**AR 22-0008**  
**Alden Apartments**  
**7800 SW Sagert Street and 20400**  
**SW Martinazzi Avenue**

**ARCHITECTURAL REVIEW BOARD**  
**FEBRUARY 22, 2023**

# Parking Standards (TDC 73C)

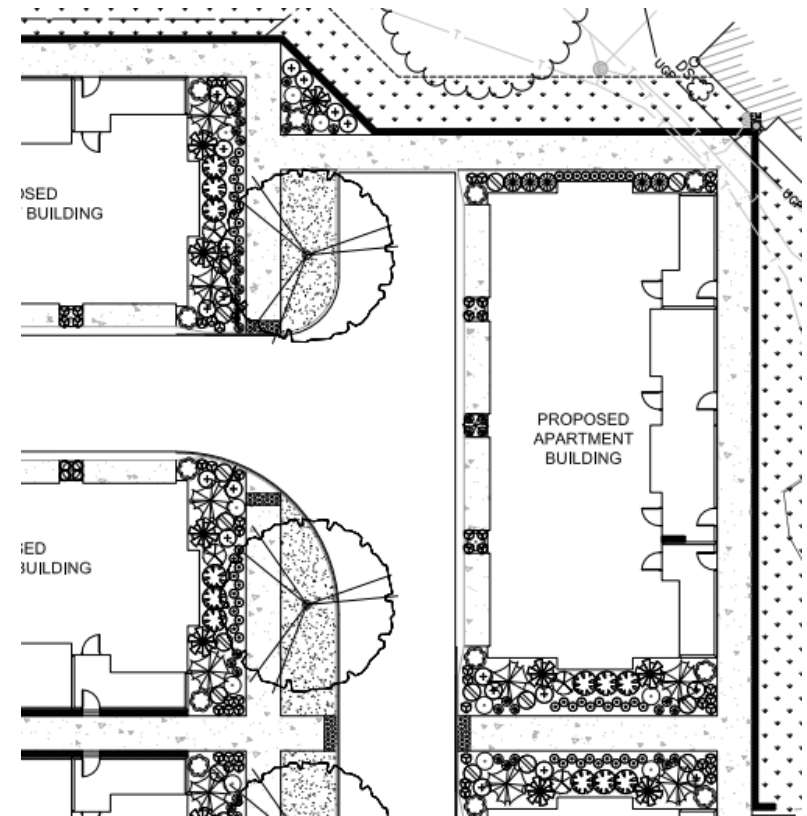
**With conditions, the proposal complies with TDC 73C.210(2):**

- Clear vision zone must be maintained at ends of on-site drive aisles and at driveway entrances, vertically between a maximum of 30 inches and a minimum of eight feet as measured from the ground level.
